Access Compliance Report Public Rights-of-Way (Curb Ramps)

Intersection ID: 27355 Main Street: JOHNSTON_RD Cross Street: BRIXHAM_HILL_AV Location: SE **ADA ID: BBD1AFFD49D0** Ramp Type: Para Initial Pass/Fail: Fail **Overall Compliance: No** Severity Score: 21.25

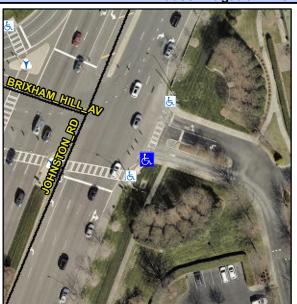
BRIXHAM MILL AV Street 1 Name Stop Condition-Street 1 Signal Street 2 Name N/A Stop Condition-Street 2 N/A Possible Solutions: Remove & Replace Entire Ramp. Surveyor Notes: N/A PROW/ADA: R304.5.1, R304.3.2

Field Measurements/Component Compliance					
Compliance Description		Data	Comp	liance Description	Data
N/A	Ramp Length LT (in)	46.0	N/A	Ramp Length RT (in)	54.0
No	Ramp Width LT (in)	46.0	Yes	Ramp Width RT (in)	60.0
No	Ramp Slope LT (%)	9.0	Yes	Ramp Slope RT (%)	7.4
Yes	Ramp XSlope LT (%)	0.3	Yes	Ramp XSlope RT (%)	0.5
N/A	Landing Length (in)	N/A	N/A	DWS Provided?	N/A
N/A	Landing Width (in)	N/A	N/A	DWS Contrast?	N/A
N/A	Landing Slope (%)	N/A	N/A	DWS Length (in)	N/A
N/A	Landing X Slope (%)	N/A	N/A	DWS Full Width?	N/A
N/A	Landing Curb? (Y/N)	N/A	N/A	DWS Offset (in)	N/A
N/A	Shared Landing?	N/A			
N/A	Gutter Ponding?	N/A	N/A	Gutter Slope (%)	N/A
N/A	Gutter Lip Ht (in)	N/A	N/A	Gutter X Slope (%)	N/A
N/A	Painted X Walk1?	Yes	N/A	Painted X Walk2?	N/A
	X Walk 1 Direction	To NE		X Walk 2 Direction	N/A
N/A	X Walk 1 Width (in)	73.0	N/A	X Walk 2 Width (in)	N/A
	X Walk 1 Slope (%)	2.4		X Walk 2 Slope (%)	N/A
	X Walk 1 X Slope (%)	0.7		X Walk 2 X Slope (%)	N/A
